### **REMARKS**

Appl. Serial No.: 10/691,866  
Examiner: Jean B. Corrielus  
Reply to Office Action of April 19, 2005

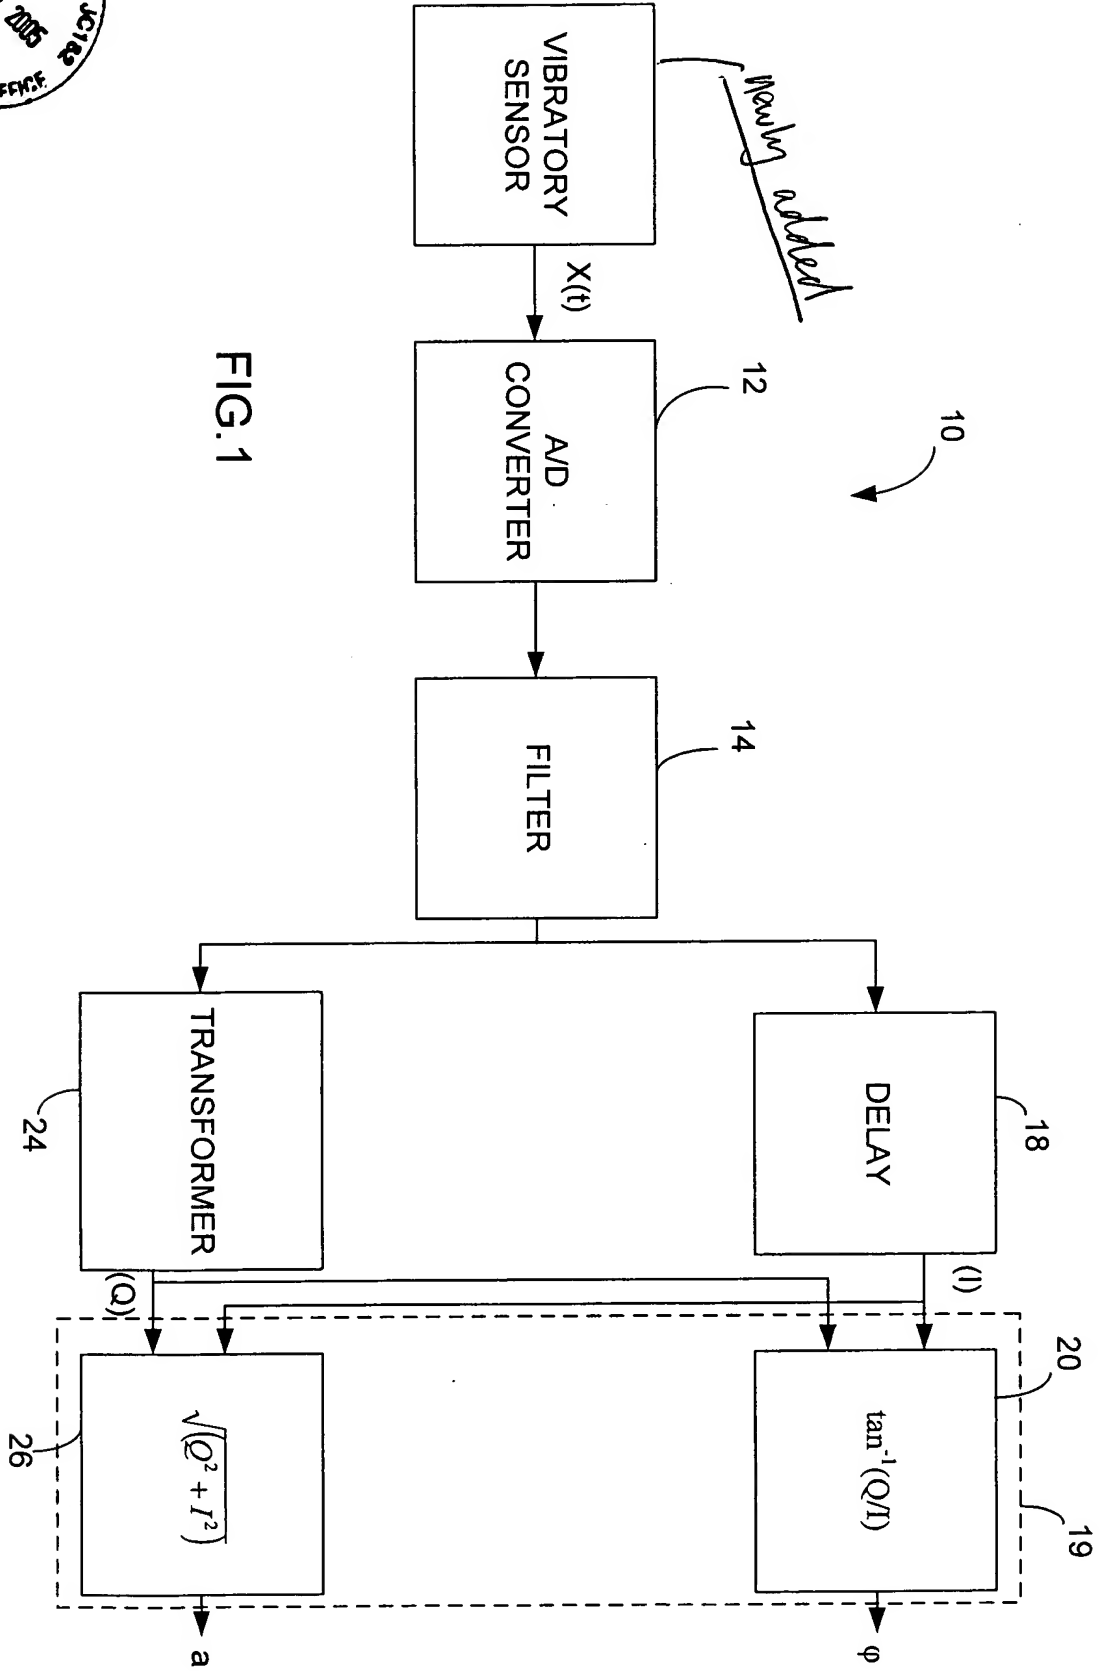
Please substitute the enclosed two sheets of drawings including FIG.1 and FIG.2 (enclosed in EXHIBIT A) for the original FIG.1 and FIG.2. In the new substitute FIG.1, a block of VIBRATORY SENSOR is added at the beginning (most left part) of the flow chart. In the new substitute FIG.2, a function block is added at the head of the flow chart. The amendments are supported by the specification. No new matter is added.
